LAND NORTHWEST OF SOUTHWATER

Proposed Worthing Road Access 5

Road Safety Audit – Stage 1

TBL19/616

DRAWING NO.	TITLE
UK0043490.9681-WSP-XX-XX-DR-TP-0104-P02	Proposed Gypsy and Traveller Left In and Out onto Worthing Road

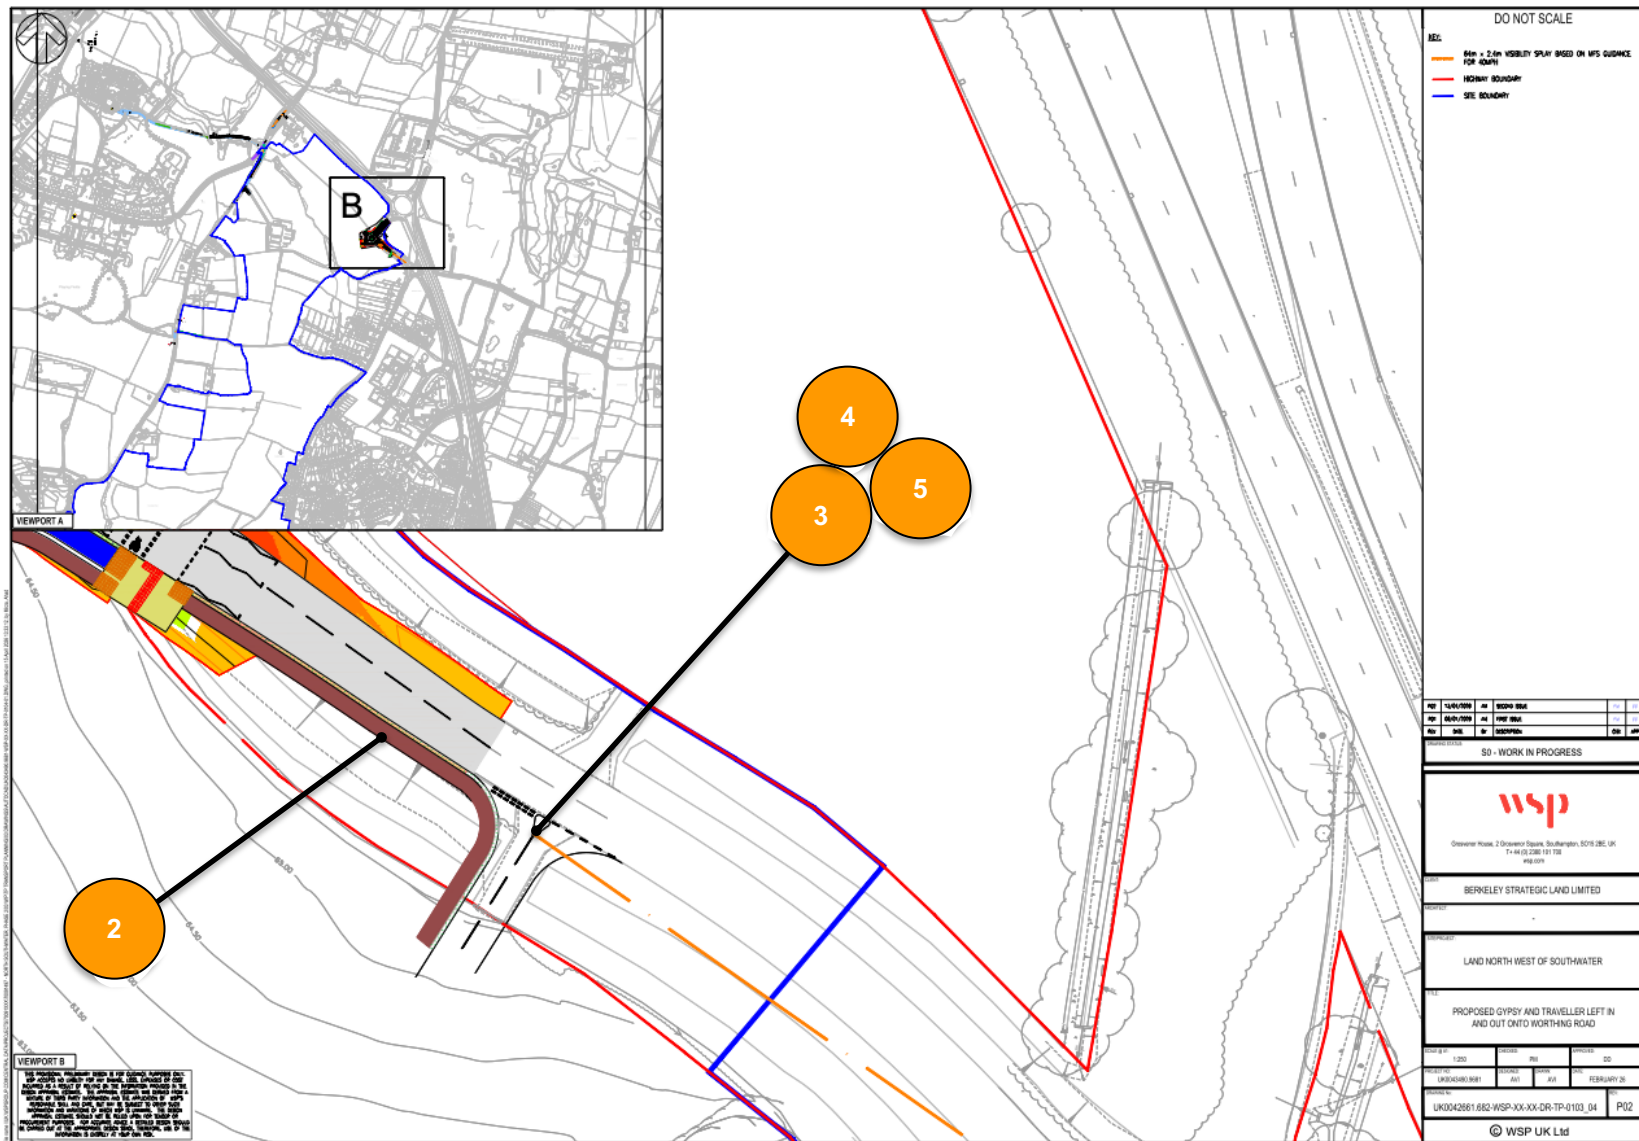
PROBLEM	1
Location	General, throughout the scheme extents
Summary	Insufficient drainage may increase the risk of flooding and single vehicle loss of control type collisions.
Significant changes to existing kerblines are proposed throughout the scheme extents. Whilst there is existing drainage provision, this may not be sufficient or appropriate for the proposed changes. Lack of surface water drainage may result in surface water ponding with the potential slide risk for vehicles during wet and subsequent cold/freezing weather conditions. This may increase the risk of single vehicle loss of control type collisions.	
RECOMMENDATION	
The Audit Team recommend that at the next stage of design, new drainage appropriate for the proposed highway works is incorporated into the scheme proposals.

PROBLEM	2
Location	Verge area adjacent to proposed access junction and footway
Summary	Embankment adjacent to footway provision may increase risk of injury to pedestrians.

The site visit has established that there is a steep gradient at the bank of the existing verge area where a new footway link is to be provided. Proposed cross sections and any associated measures to address the level difference or footway retainment have not been provided at this stage of audit.

This may result in pedestrians falling down the embankment with an increased the risk of injury to pedestrian.

PROBLEM	3
Location	Proposed access junction
Summary	Reduced visibility splay may increase the risk of vehicle pull-out type collisions.
The site visit has established that the achievable visibility splay to the right when exiting may be impacted upon by the presence of vegetation. A lack of visibility at the junction may increase the risk of pull out type collisions.	
RECOMMENDATION	
The Audit Team recommend that the achievable visibility splays are not compromised.

PROBLEM	4
Location	Development access junction
Summary	Pull out type collisions.

The site visit has established that there is a significant level difference between Worthing Road mainline carriageway and the proposed development site.

Vehicles waiting to emerge onto the mainline from a standing start could experience difficulties due to the difference in levels. This could impact upon a driver's ability to see clearly when looking to the left and right on approach to the junction exit and may increase the risk of vehicle to vehicle pull out type collisions.

PROBLEM	5
Location	Proposed access junction
Summary	Increased risk of kerb strikes or footway overrun resulting in loss of control or vehicle to pedestrian type collisions.
At this stage of audit, vehicle swept paths have not been provided. Without this information it is unclear whether the relevant design vehicles that may use this junction can safely carry out their turning movements without hitting kerbs/overrunning footway areas. This may increase the risk of single vehicle loss of control or vehicle to pedestrian type collisions.	
RECOMMENDATION	
The Audit Team recommend that vehicle swept paths are carried out to confirm that vehicles can safely negotiate all expected movements.

The Audit Team recommend that where verge areas cannot be reprofiled adequately that proposals include the provision to remove the potential for pedestrian injury.

The Audit Team recommend that at the detailed design stage a dwell/plateau should be provided for the development site junction where it meets the development access road.

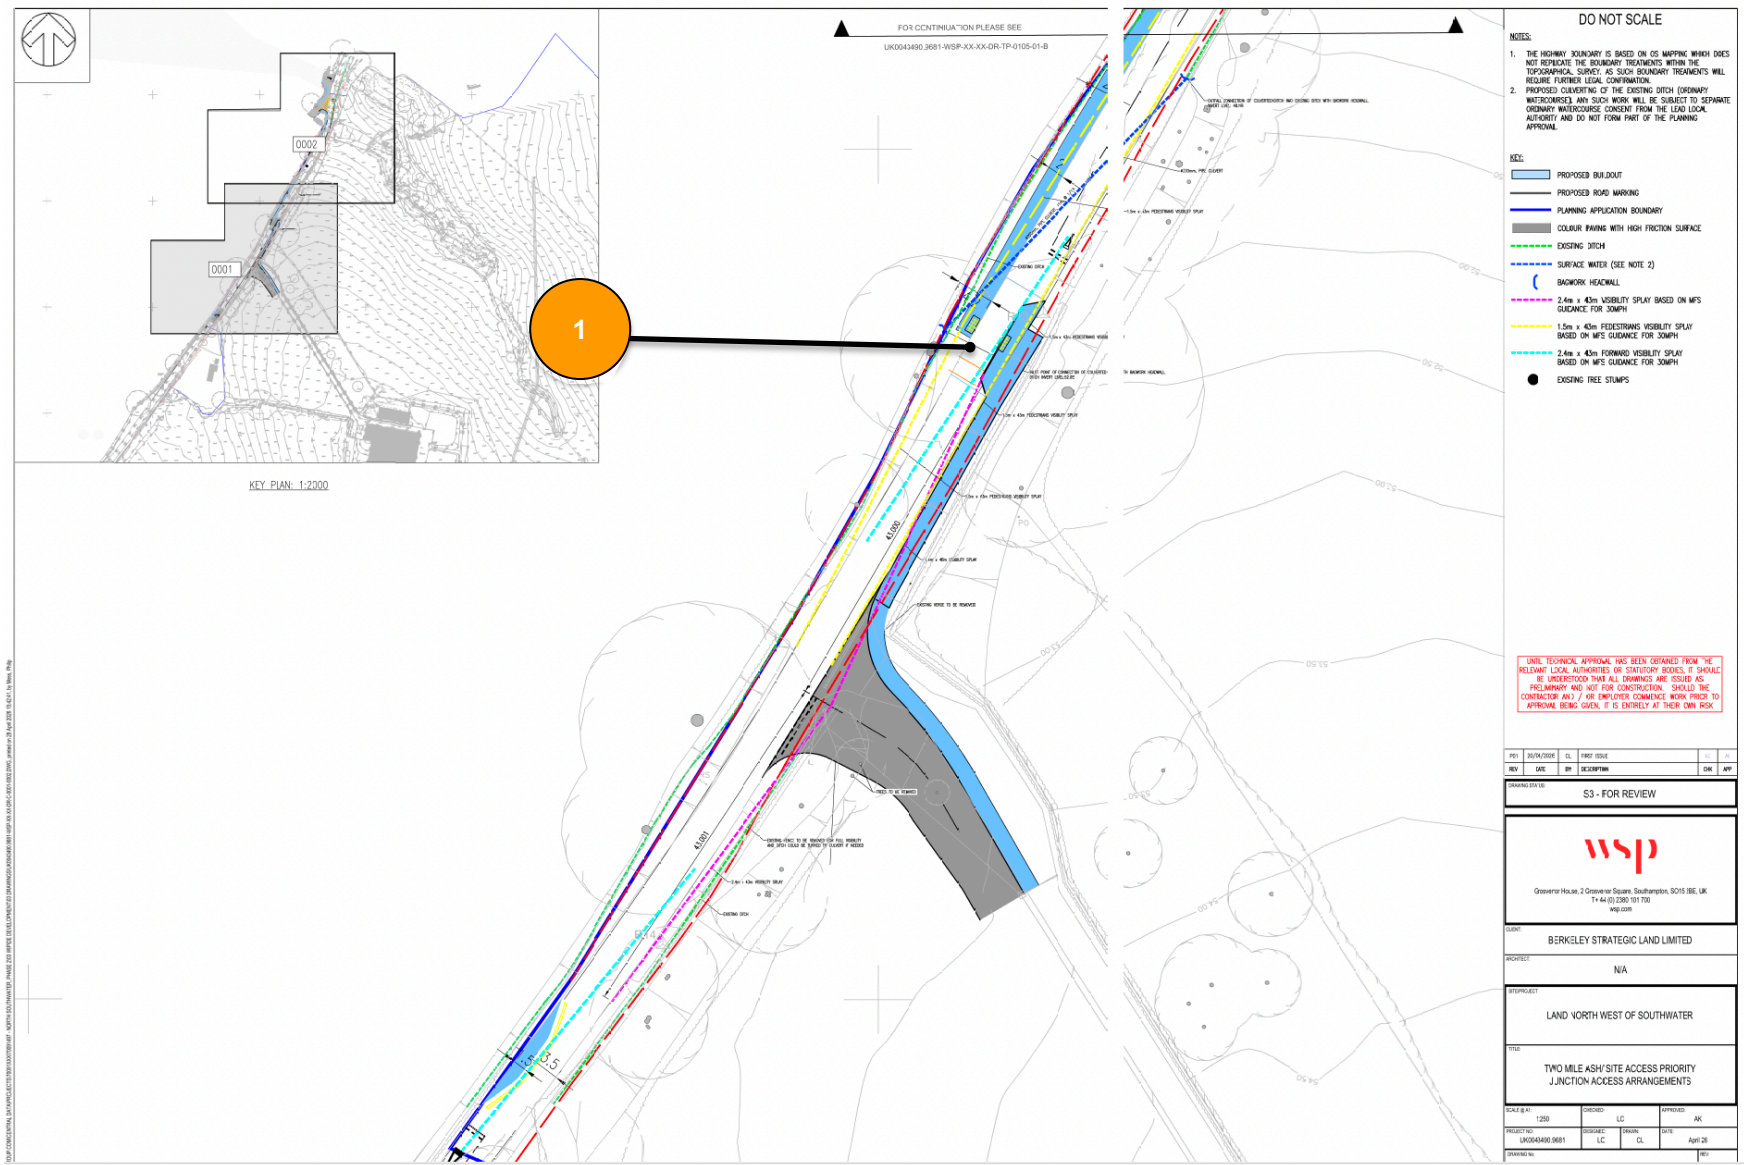
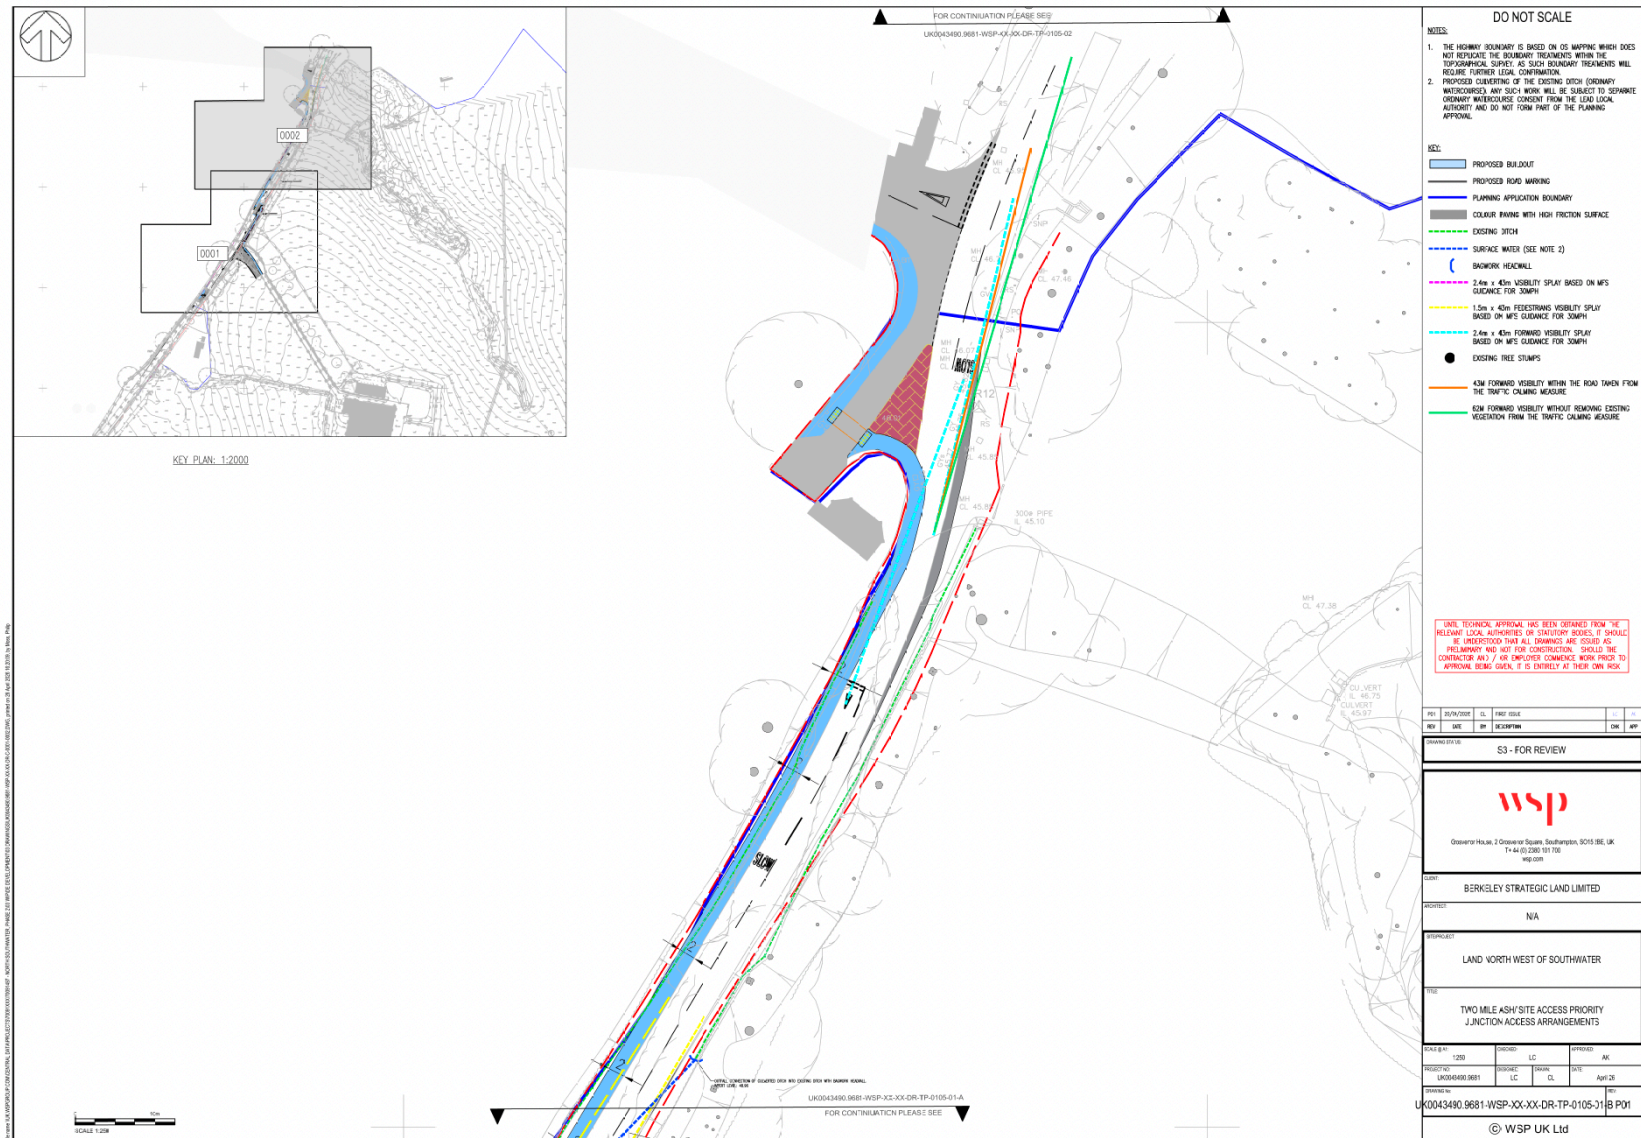
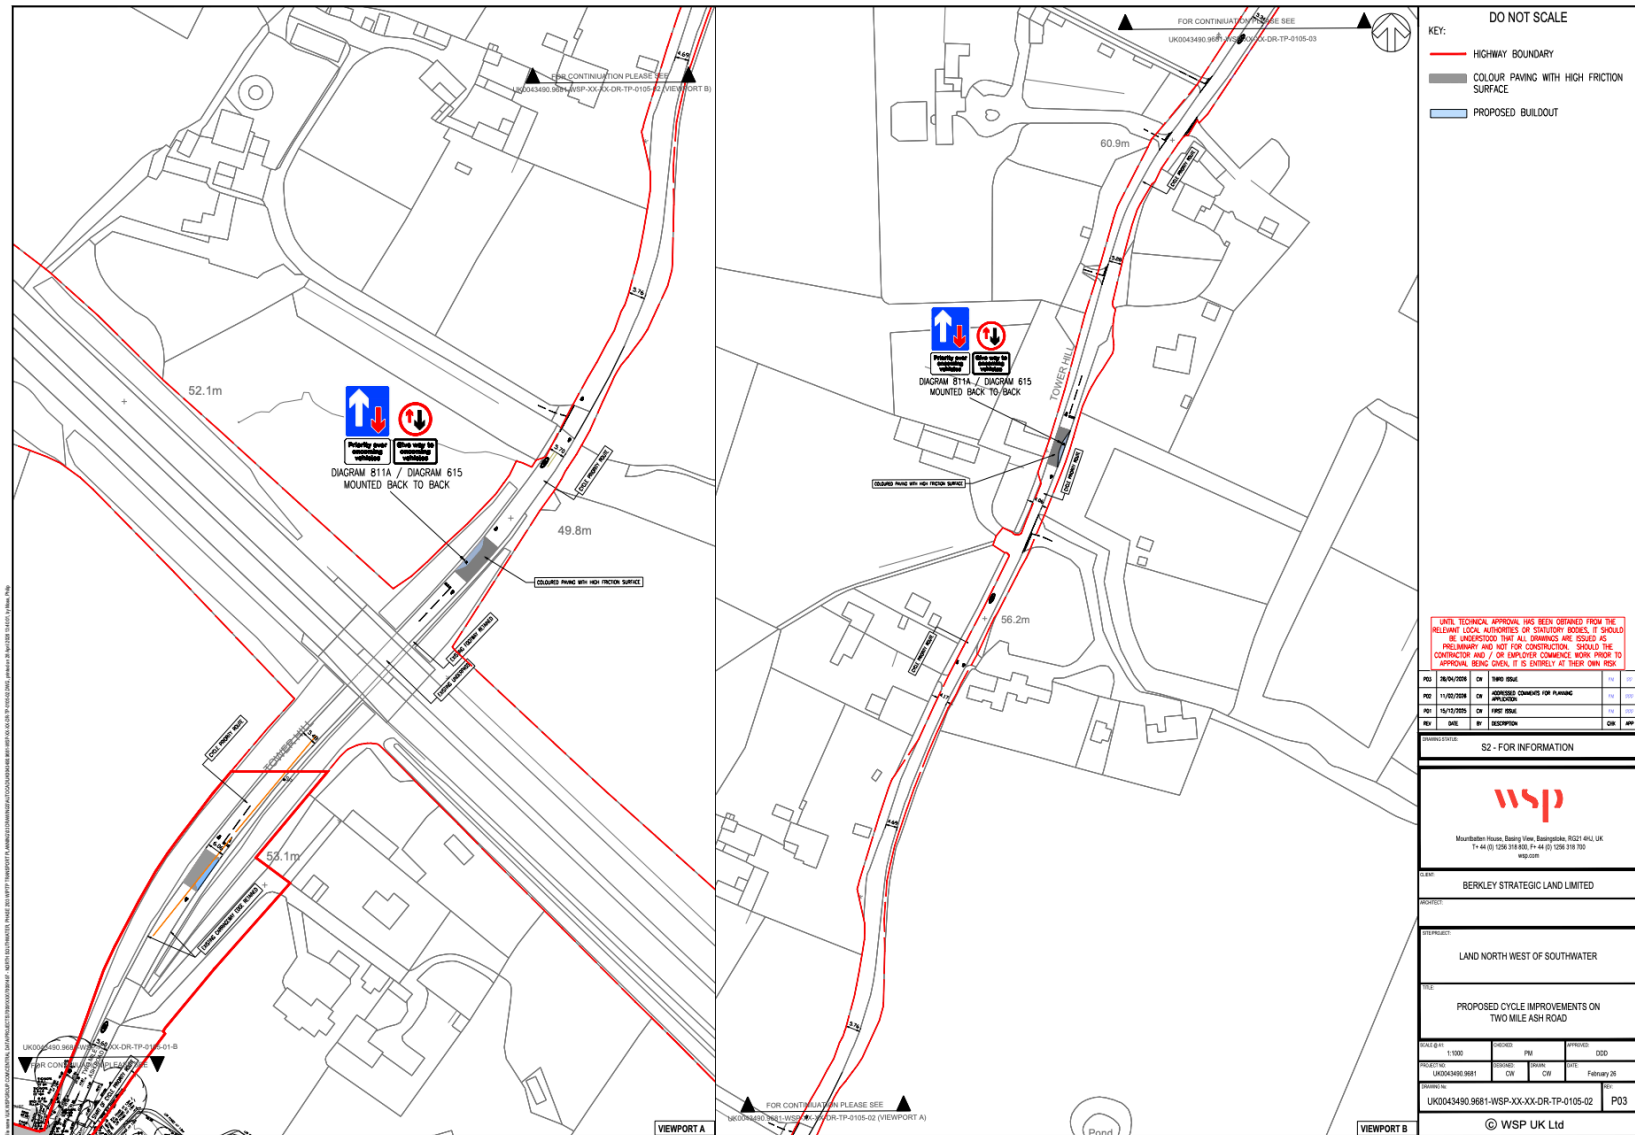
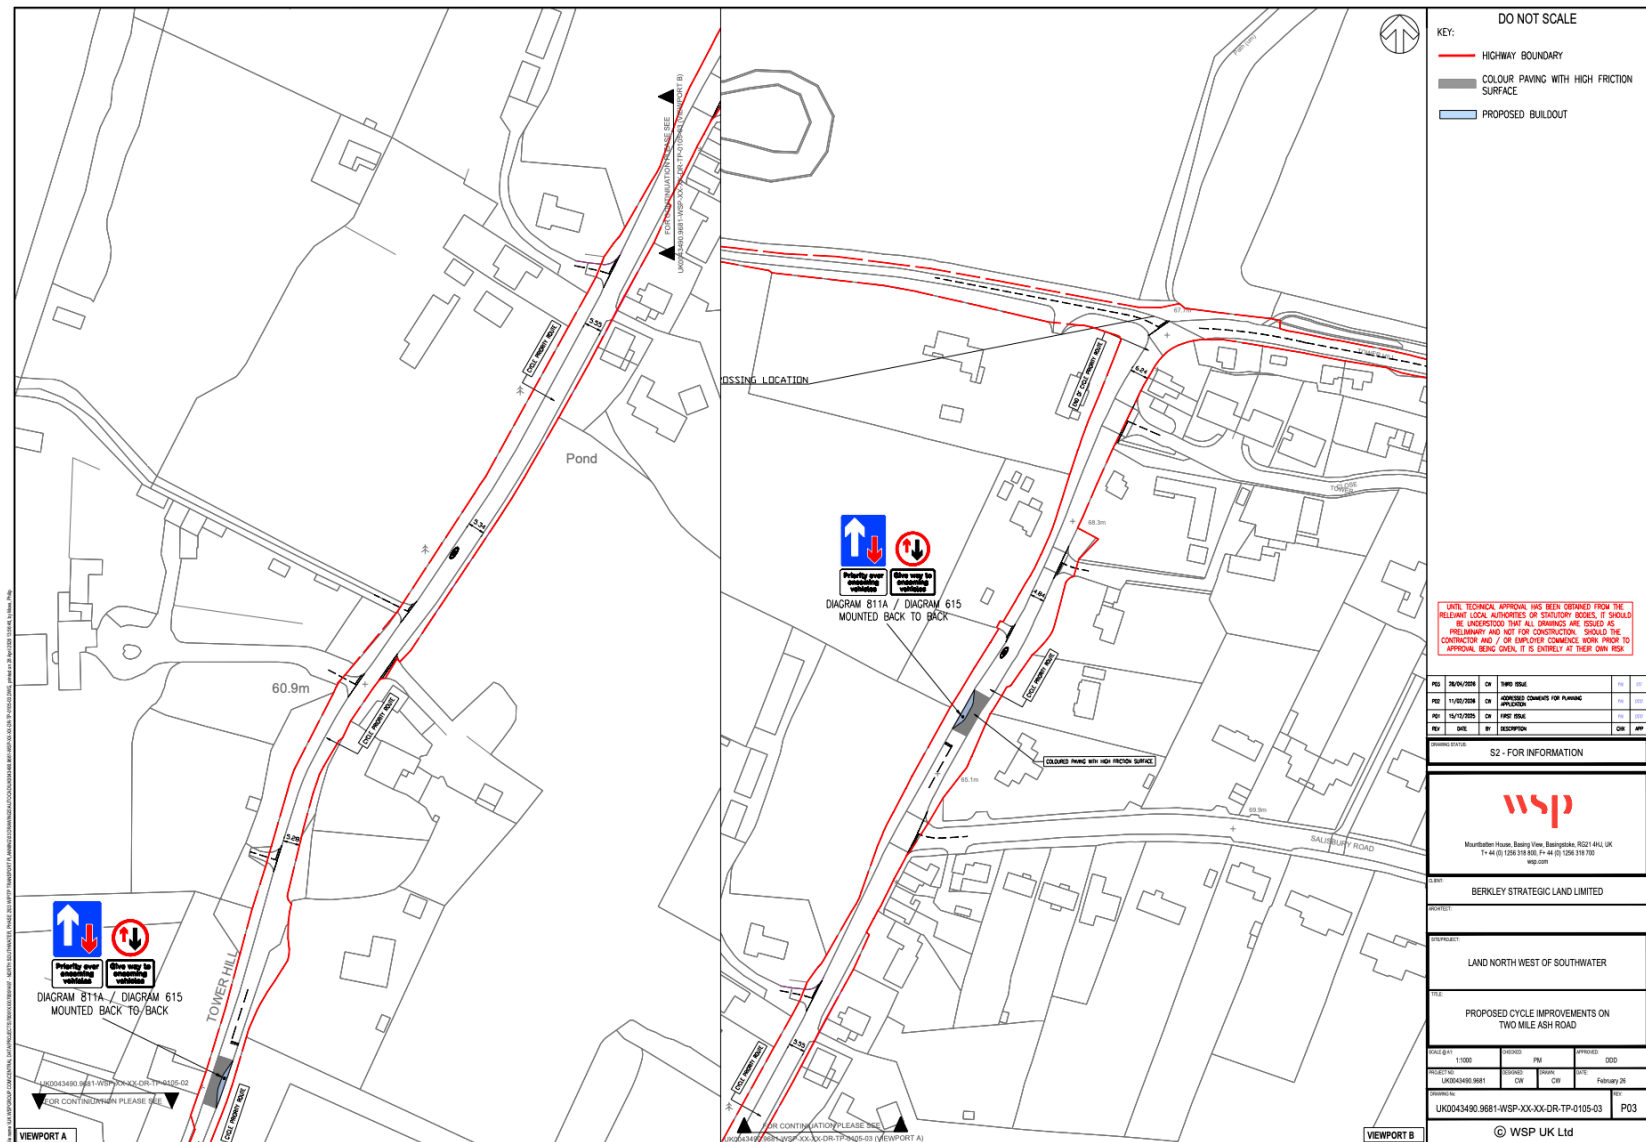
PROBLEM	1
Location	Two Mile Ash Road, southern-most section adjacent to Access 4
Summary	Increased risk of vehicle to vehicle head-on or vehicle to pedestrian type collisions.
A buildout incorporating an uncontrolled crossing facility is proposed to the north of Access 4. The site visit has established that there is an existing carriageway crest to the south of this proposed measure. This reduces driver intervisibility between northbound drivers and those manoeuvring around the buildout feature with an increased risk of vehicle to vehicle head-on type collisions. Further, pedestrians using this crossing facility may not be seen by northbound drivers with a risk of vehicle to pedestrian type collisions.	
RECOMMENDATION	
The Audit Team recommend that the buildout is sited such that sufficient intervisibility is provided and that pedestrians can cross safely.

PROBLEM	2
Location	General, throughout the scheme extents - approaches to the priority working traffic calming
Summary	Insufficient skidding resistance approaching the proposed priority working traffic calming. Risk of overshoot or vehicle to vehicle rear end shunt type collisions.
The scheme proposals indicate that new traffic calming measures in the form of priority working is proposed. At this stage of audit, no information has been provided regarding the skidding resistance of the carriageway surface course. If the skidding resistance of the carriageway is inadequate there may

be an increased risk of overshoot or vehicle to vehicle rear end shunt type collisions, particularly when the carriageway is wet.

PROBLEM	3
Location	General, Proposed localised narrowing/buildout
Summary	Insufficient drainage may increase the risk of flooding and single vehicle loss of control type collisions.
At this stage of audit construction details for the buildouts and associated drainage proposals have not been provided. A lack of appropriate drainage at locations of proposed traffic calming features may increase the risk of flooding in these areas which may result in an increased risk of single vehicle loss of control type collisions.	
RECOMMENDATION	
The Audit Team recommend that appropriate drainage is incorporated into the scheme proposals.

PROBLEM	4
Location	General, proposed localised narrowing/buildouts
Summary	Risk of vehicle to cyclist collisions.

The proposals introduce a number of localised buildouts. This has the effect of narrowing the carriageway. At this stage of audit, carriageway widths have not been provided.

Cyclists may be at risk of vehicles attempting to overtake through narrowed sections resulting in vehicle to cyclist type collisions.

PROBLEM	5
Location	General, throughout the scheme extents
Summary	Risk of vehicles striking the proposed buildout feature.
A priority buildout traffic calming measure is proposed. The drawings at this stage of audit do not show any means of highlighting this feature, either by means of road markings, signing or lighting. A lack of clear guidance for drivers at the kerbed buildout. may increase the risk of vehicular strikes and vehicle to pedestrian type collisions, particularly during the hours of darkness.	
RECOMMENDATION	
The Audit Team recommend that the kerbed buildout should be visible to drivers during all lighting conditions and that sufficient warning of the feature is provided.

The Audit Team recommend that the appropriate skidding resistance for a stress site is provided for the approaches to the priority working traffic calming measures.

The Audit Team recommend that an appropriate width of carriageway is proposed in line with current best practise.
